DOCUMENT - 2024-149P
Second Floor Expansion, 3190 Mavis Road, City of Mississauga,
Project 22701

ADDENDUM 3

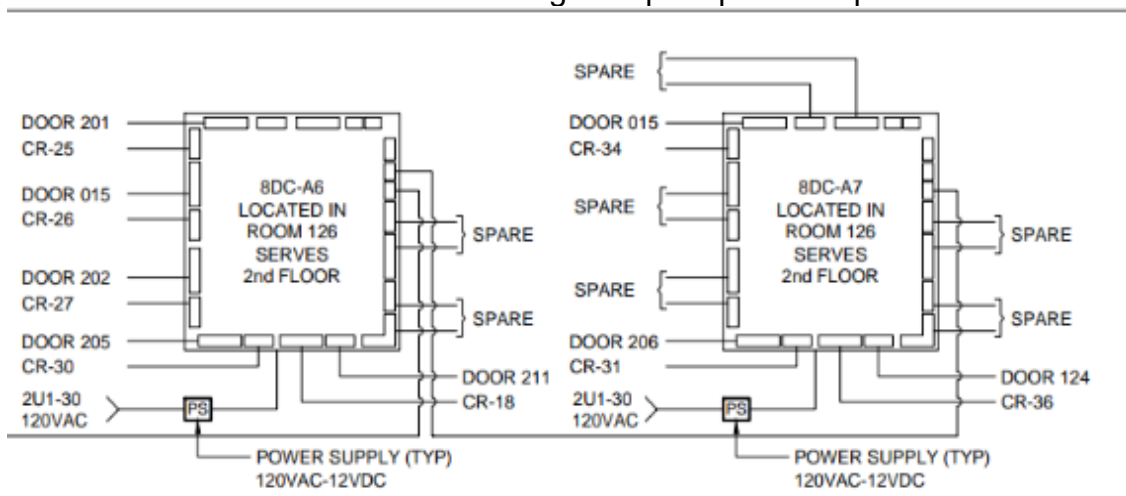
There should be spare reader ports on one of the door controllers for the requested additional card readers. However, the pictures of the controllers provided on the security drawings are the wrong controllers. Please upload pictures of all the door controllers in the IT room to confirm the number of spare reader ports available.

Sufficient spare reader ports are available on the existing wall mounted 8DC in the IT room on the ground floor for securing the new doors with access control. Pictures of the door controllers showing the spare ports are provided below.
